**LOCAL HISTORIC DISTRICT:** Plaza Midwood

**PROPERTY ADDRESS:** 2101 The Plaza

**SUMMARY OF REQUEST:** Deck addition, door/window changes

# HDCRMI 2019-00351

# REAR ELEVATION

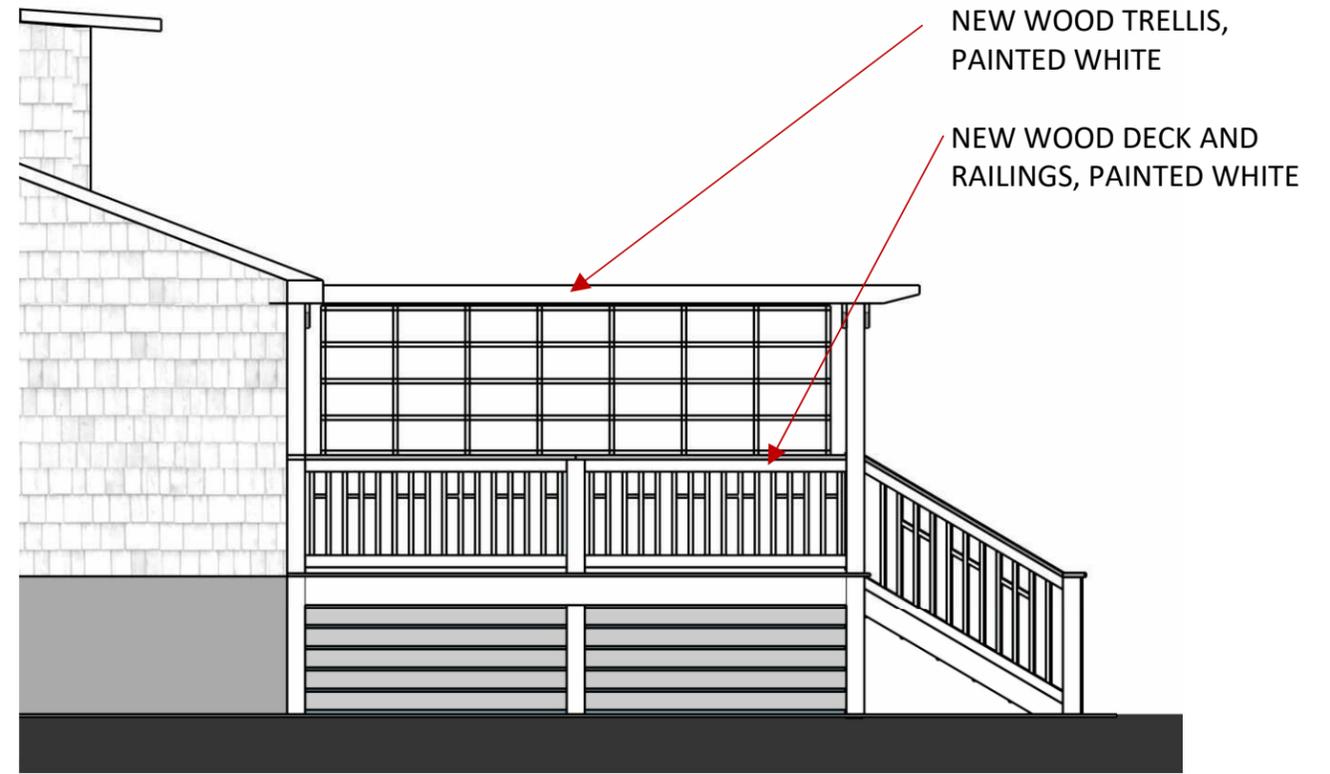
1. Dimensions provided for materials only. Total height, width, depth of trellis and deck not provided.
2. Fenestration design unchanged.
3. Some documentation provided.

1. Staff would request that the applicant provide dimension information (height, width, depth) for the deck and trellis. Otherwise, the existing deck is a modern addition, and the replacement deck and trellis feature are not incongruous with the District and meets the guidelines for Additions, page 7.2.
2. The Commission will determine if the paired windows and the single windows can be converted to door openings.
3. Minor revisions may be approved by staff.
